N00109.AR.002679
NWS YORKTOWN
5090.3a

EMAIL AND NO FURTHER COMMENT FROM U S EPA REGION III REGARDING DRAFT TIER II SAMPLING AND ANALYSIS PLAN SITE 34 DATA GAP INVESTIGATION NWS YORKTOWN VA
10/4/2013
U S EPA REGION III

From: William.Friedmann@CH2M.com [mailto:William.Friedmann@CH2M.com]
Sent: Friday, November 22, 2013 3:19 PM
To: Oduwole, Moshood
Cc: Wade.Smith@deq.virginia.gov; james.gravette@navy.mil; Kim-Lee.Yarberry@ch2m.com
Subject: Site 34 Navy Response to BTAG Comments

Figure 8
Proposed Soil and Sediment Sample Locations
Site 34 SAP
Naval Weapons Station Yorktown
Yorktown, Virginia

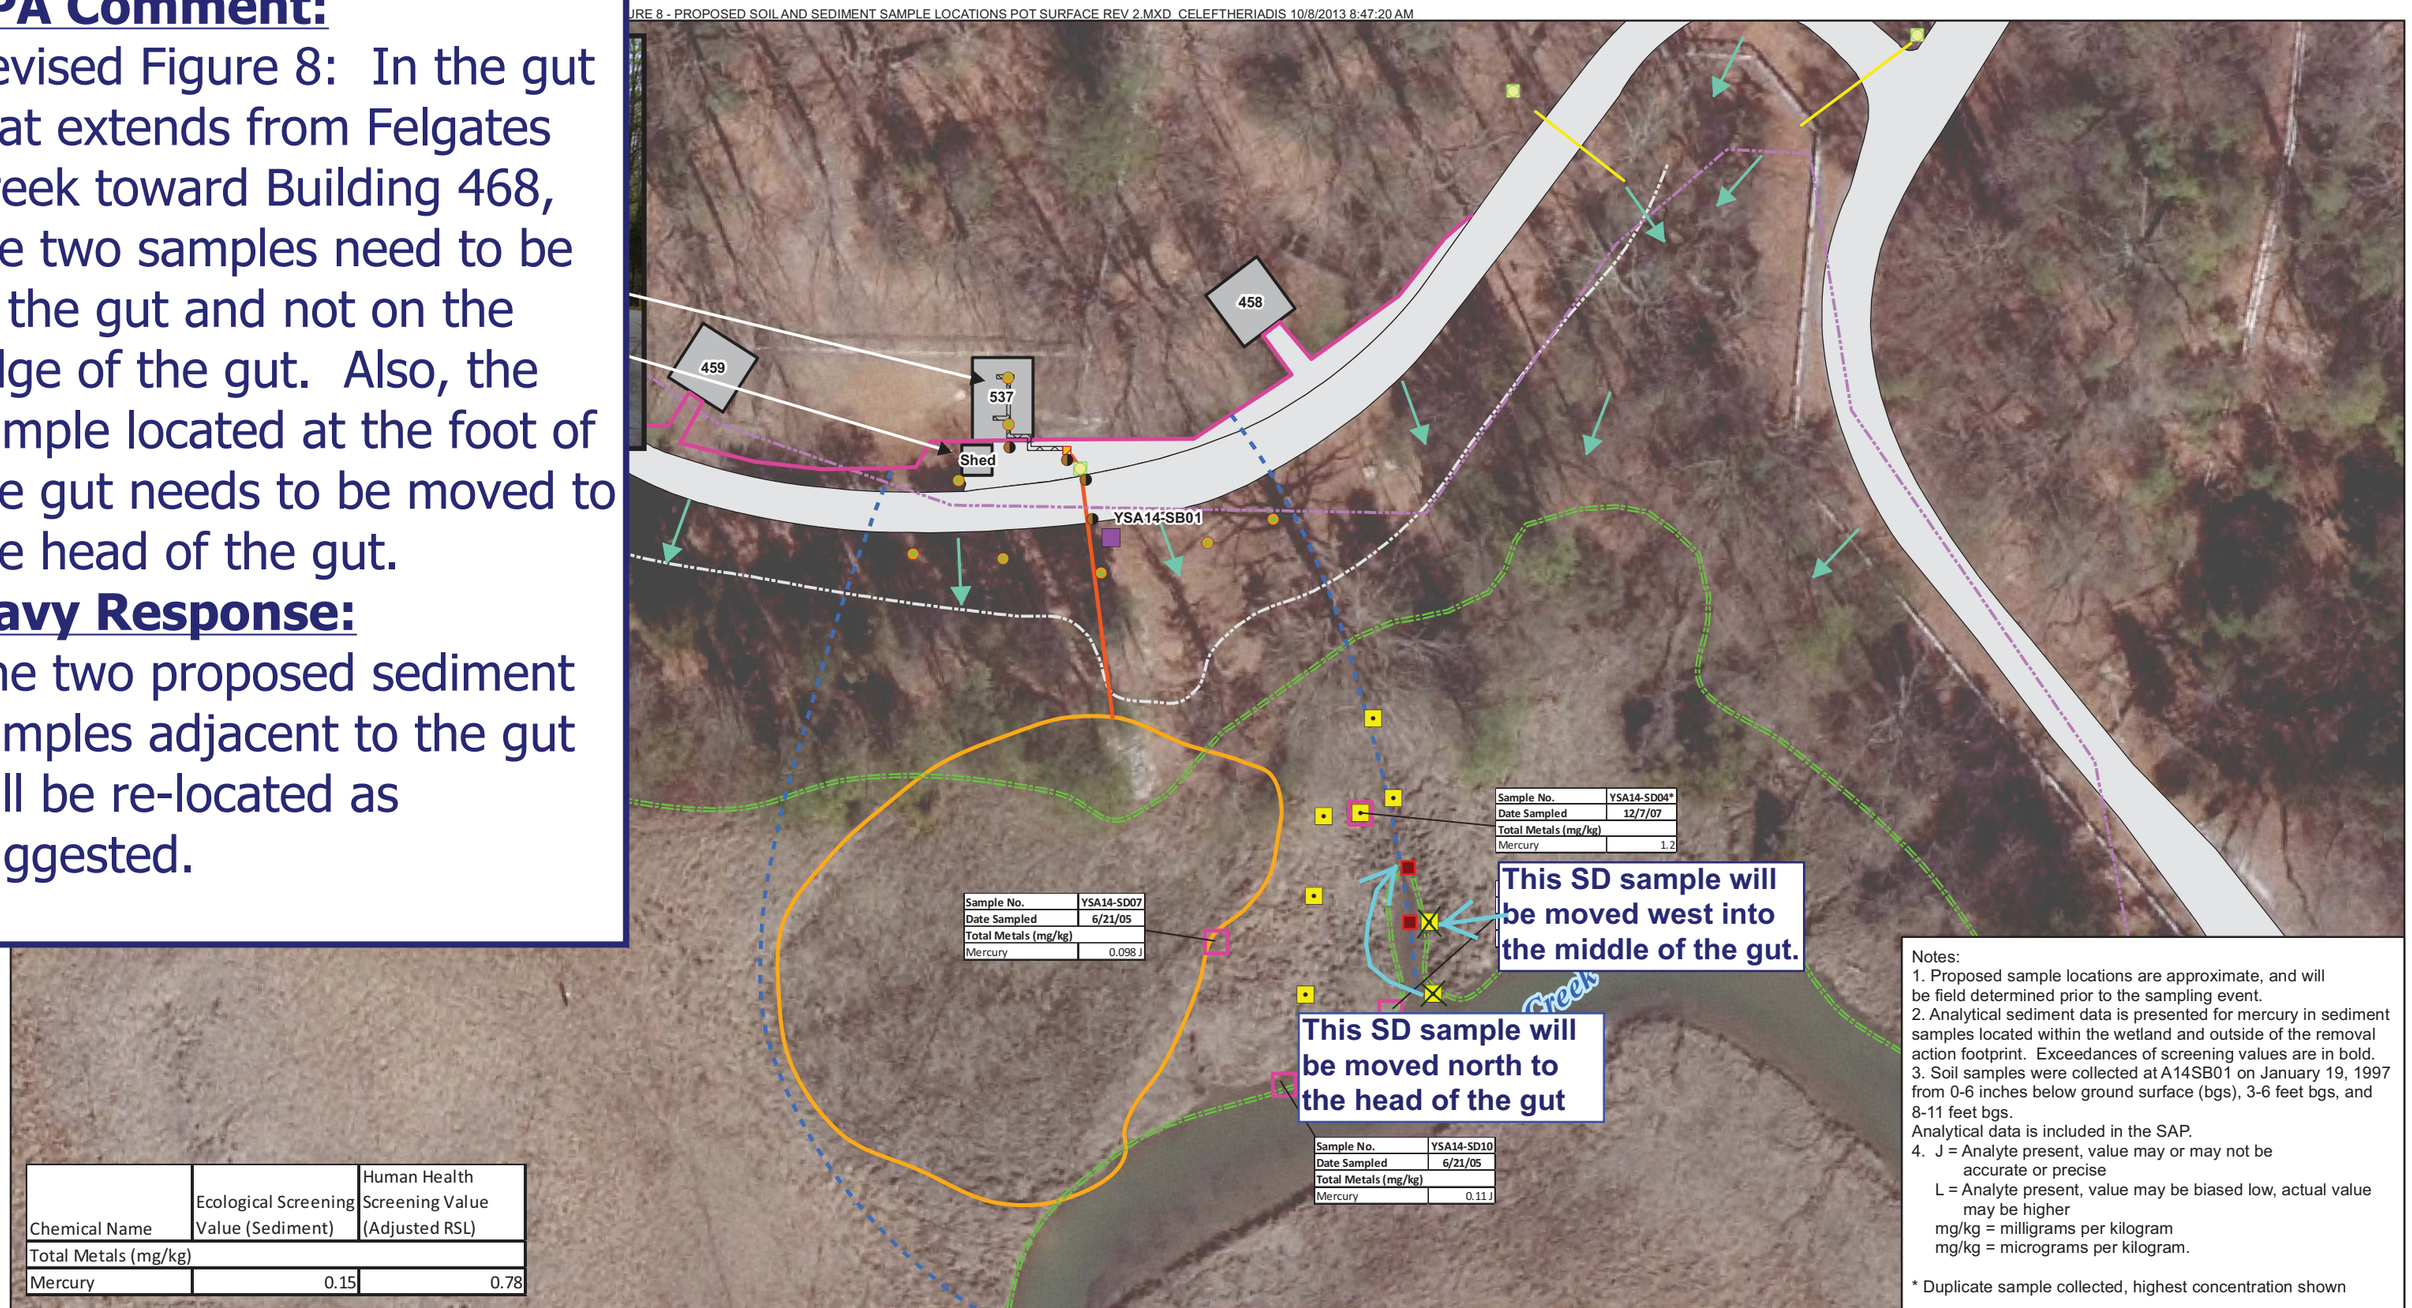
Revised Figure 8: In the gut that extends from Felgates Creek toward Building 468, the two samples need to be in the gut and not on the edge of the gut. Also, the sample located at the foot of the gut needs to be moved to the head of the gut.

The two proposed sediment samples adjacent to the gut will be re-located as suggested.

Figure 8
Proposed Soil and Sediment Sample Locations
Site 34 SAP
Naval Weapons Station Yorktown
Yorktown, Virginia

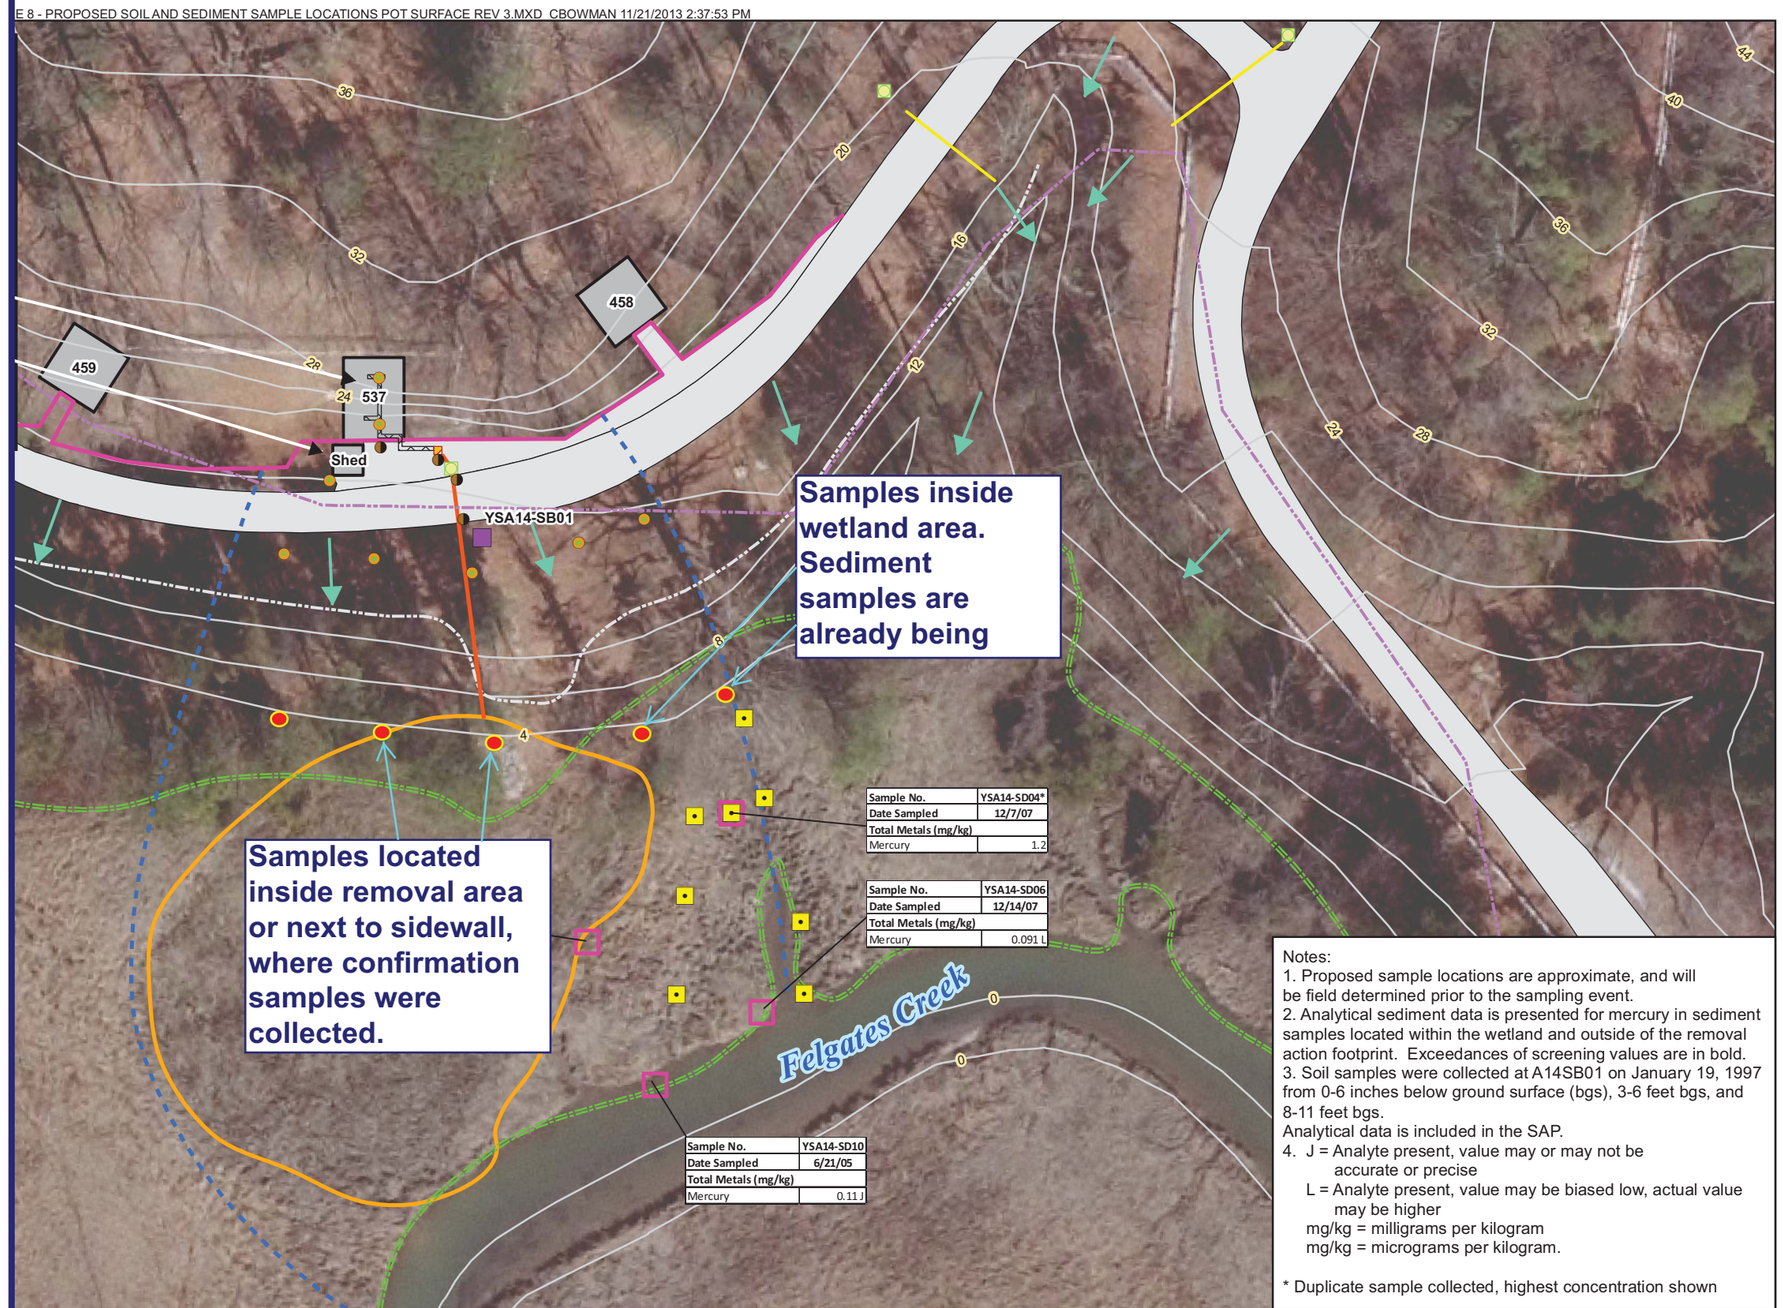
The five soil samples on the slope between Building 657 and the wetland may not be in the most advantageous locations. This appears to be a steep slope and a better place for these samples would be at the toe of the slope. These samples should be relocated.

No change in soil sample location is proposed for the following reasons:

1. If moved, two of the soil locations would be located within the removal area or along the removal area boundary, where confirmation wall samples were collected. Therefore, any contaminants which may migrated to this area have been removed.
2. If moved, two other soil locations would be located within the wetland area, which is being evaluated by proposed sediment samples.
3. The objective of the soil portion of the data gap investigation is to confirm soil contamination is not present in the vicinity of Building 537 and its associated piping that could present a source to groundwater, thereby impacting remedy effectiveness. Moving the location of the soil samples would not adequately meet this objective.
